### STAFF REPORT AND NOTICE OF DECISION

#### Tri-Mountain Station South

File No. PLZ-21-0072-0075, 0095

Figure 2: Site Plan

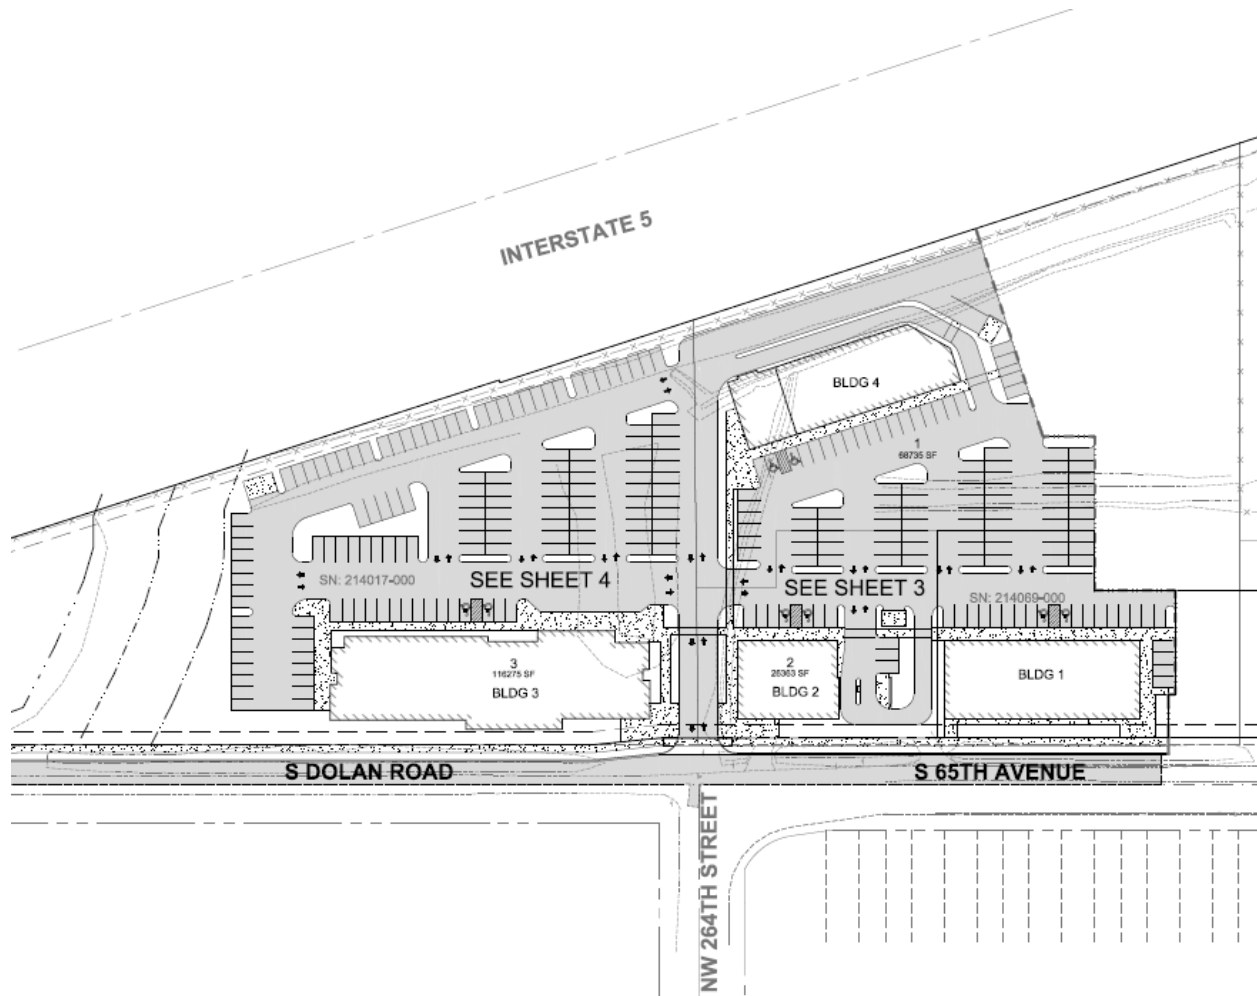
Following the proposed binding site plan, each of the four lots will comply with the CRB dimensional standards. See Section IV.B. The binding site plan proposal complies with the RUACP. The commercial development project associated with the binding site plan includes street and sidewalk improvements, stormwater facilities, open space, water supply, and sanitary waster disposal, and as such serves the public safety and welfare. Lots 1, 2, and 3 have direct legal access to S 65<sup>th</sup> Avenue/S Dolan Road, which are public streets. However, Lot 4 does not appear have legal access to a public street.

- The applicant shall submit a sheet showing the preliminary binding site plan (land division) only. The preliminary binding site plan shall demonstrate that Lot 4 has legal access to a public street by means of an access easement.

- Prior to engineering approval, the applicant shall update the landscape plans to show an enhanced L5 buffer along the western site boundary, including understory trees at an interval closer than 8 feet, shrubs, or a similar measure approved by the Community Development Director.
